**LETTER OF SUBMITTAL**  
**KFM Skyway Project # 04-012024**

**Subject:** USI - KFM NCR #27R1 (USI NCR #04-24 Rev. 1) Response to CTL-4438

Subject: Response to KFM-SUB-002143R01: USI NCR 04-24 Rev.1 - Dimensions

DIAPHRAGM "pa86"

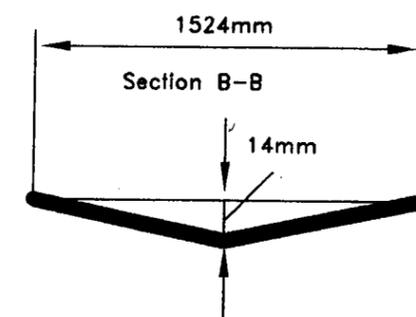
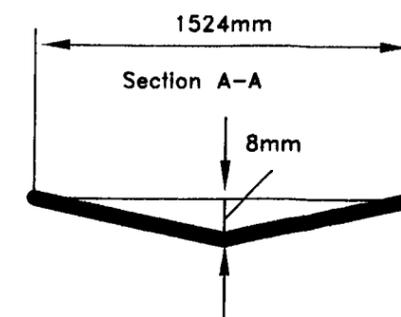
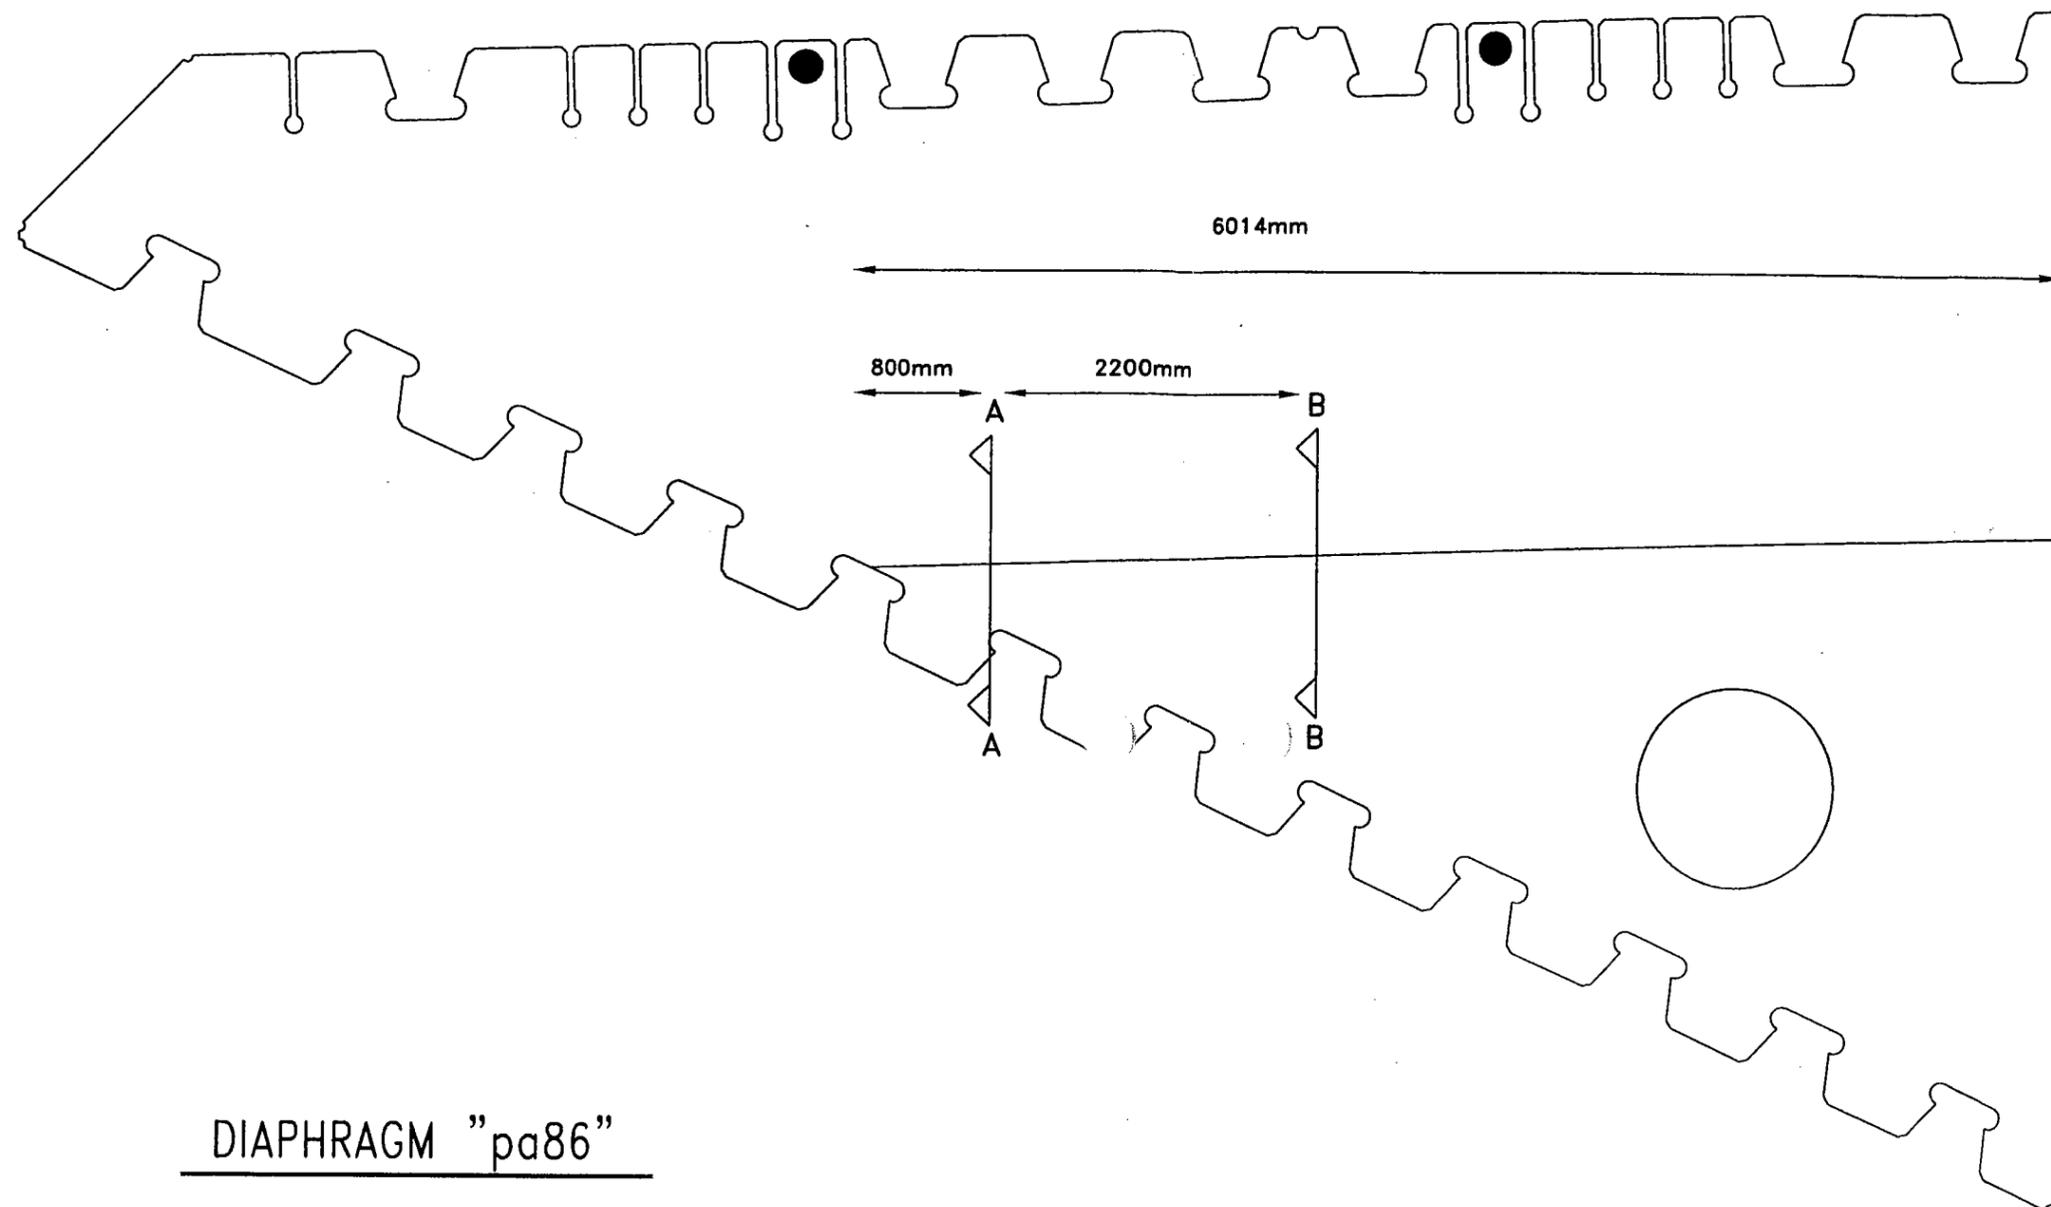
The State has reviewed KFM-SUB-002143R01: USI NCR 04-24 Rev.1 - Dimensions regarding the request to heat straighten weld distortion in the butt weld in wing plate diaphragm pa86. The State will allow USI to apply one progression of heat in accordance with USI's "Typical Butt Weld Distortion Repair Procedure" included with this submittal. Heat straightening should occur in the presence of a State QA inspector. After the first progression of heat is applied, the measurements of the affected dimensions should be communicated to the State QA inspector on the shop floor. At this time, the State may approve the second progression of heat in accordance with the "Typical Butt Weld Distortion Repair Procedure." Subsequently, non-destructive testing (NDT) shall be performed in accordance with AWS D1.5 Section 6.7.3.

The State also requests future submittals include additional information concerning the overall deviation from flatness. In addition to the deviation from flatness measured across the 1524 mm length at localized areas of distortion, the State requests the deviation from flatness measured across the total edge-to-edge distance perpendicular to the weld.

DATE: March 30, 2004 April 26, 2004 Rev1	INITIATOR Ralph Seeley	DEPARTMENT: Production	NCR NUMBER: 04-24 Rev. 1
JOB NUMBER: 23932	JOB NAME: SFOBB	DRAWING 86	CODE/SPECIFICATION AWS D1.5
NONCONFORMANCE: Wing plate diaphragm pa86 has excessive weld distortion in the butt weld. From the left end looking at the shop drawing, the first 800 mm is 8 mm out of flat. From 800 mm to 3000 mm is 14 mm out of flat.  Revision 1, As requested, a sketch needs to be supplied to indication location of excessive distortion.			
QA MANAGER Chris Amonson		DATE: 3/30/04	
RECOMMENDED DISPOSITION: Areas distorted by welding shall be straightened by application of a limited amount of localized heat with minimal mechanical assistance. The temperature of heated areas shall not exceed 1100 degrees F. (600 degrees C.). All application of heat to base metal shall be controlled by using Temp Sticks or Thermocouples to assure that heat does not exceed allowable. Weld joints are to be heated on both sides, parallel to the weld. This line heat will be located approximately 1 to 3 inches from the weld joint on the outside of the surface that is distorted.  Revision 1, Please find the attached sketch for location and amounts of distortion.  Caltrains requires witnessing the repair and will only allow one heat progression. Record results after line heats are cooled.

See ATTACHED sketch for Deviations From Flat  
at Diaphragm Butt Splice.  
ALL Dimensions ARE within prescribed Tolerances  
after  $\pm$  Heat Progression.

The Engineer has reviewed KFM-SUB-002143R02: USI KFM NCR #27R1 (USI NCR #04-24 Rev.1) Response to CTL 4438. The Engineer takes no exception to the subject submittal and agrees the Contractor has sufficiently addressed this NCR. As a result, USI NCR 04-24 Rev.1 is resolved.
